REPORT OUTLINE FOR AREA PLANNING COMMITTEES**Report No.**

Date of Meeting	04 September 2019
Application Number	19/02713/LBC
Site Address	Merchant House 34 High Street Royal Wootton Bassett SN4 7AF
Proposal	Replacement of UPVC windows, replacement of damaged lintels and rebuilding of front wall above windows
Applicant	Mr Johnathan Bourne on behalf of Royal Wotton Bassett Town Council
Town/Parish Council	ROYAL WOOTTON BASSETT
Electoral Division	Wootton Bassett South– Cllr Hurst
Grid Ref	406728 182586
Type of application	Listed Building Consent
Case Officer	Caroline Ridgwell

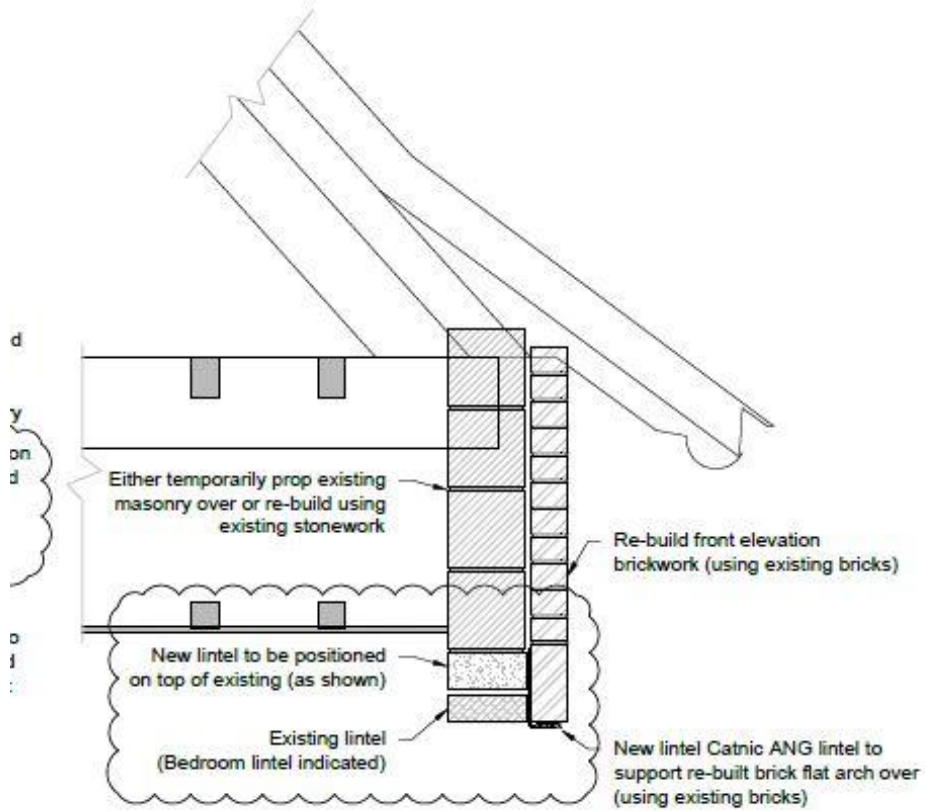
1. Whether the addition of any form of structural reinforcement is necessary to beef up the lintols over the two first floor window openings on the front elevation;
2. If reinforcement is necessary, what form should it take.

1. Is strengthening necessary?

The approach by the applicants appears to be to add reinforcement as a preventative measure. A problem with the roof truss in the attic above had been discovered and consent granted for structural works to that under 17/00989/LBC. That failure resulted in lateral movement, pushing the gable wall out but may also have put pressure on the walls below (front walls). The submitted heritage statement says that "*The principle of the replacement of the failed timber lintels has previously been accepted as it formed an integral part of application reference 16/06854/LBC*". It was not in fact discussed as part of the 2016 application. Furthermore, the statement goes on to say that "*...the existing lintels exceed their allowable bending stress and that the inner timber lintels should be replaced, with either timber or pre-stressed concrete. The proposals seek to comply with these recommendations to ensure the structural stability of the building.*" The submitted report from the structural engineer (ref 4158-R02) states in point 2.4 "*The existing timber lintels supporting the inner skin masonry and roof structure over the existing window openings do not comply with British Standards by calculation.*" There are differing arguments being put forward as to whether the lintols over the first floor front elevation windows have actually failed, are on the point of failure, or may fail if additional weight is added because they do not tie in with guidance for British Standards.

The proposals appear to go beyond what is necessary, thereby harming the significance of the heritage assets through unnecessary intrusive works, the addition of new materials and non-traditional details in the form of catnic lintols. Looking at historic buildings and trying to achieve structural standards found in new buildings leads to harmful works that are not necessary.

1-1 Section 1-1
Scale: 1:20

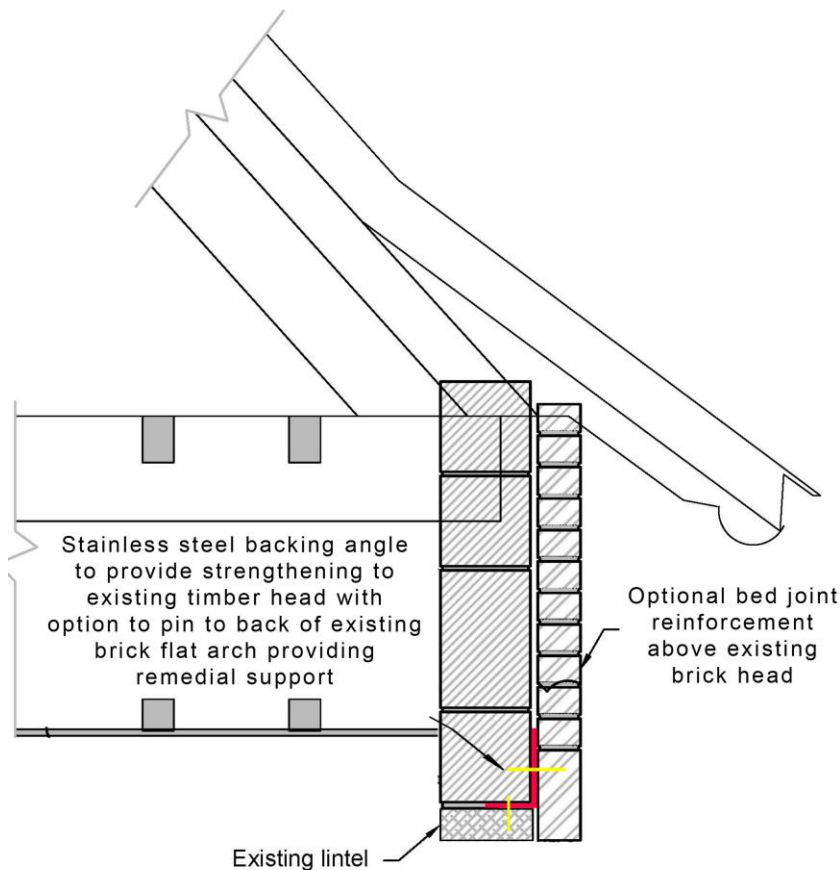
2. If some strengthening is required, what form should it take?

Should it be agreed that the lintols do require strengthening in some way, there is a less intrusive and more subtle method than the one proposed. An alternative solution has been put forward which adheres to the conservation approach that the least intrusive solution is most acceptable for a heritage asset. The more conservative solution would be to strengthen the lintols so that they are adequate to carry the required loading. The applicants proposals appear to be based on requirements for a new building and would be far more intrusive. A catnic lintol is not a traditional detail, it is found on new buildings.

Mann Williams Alternative Less intrusive and not externally visible solution
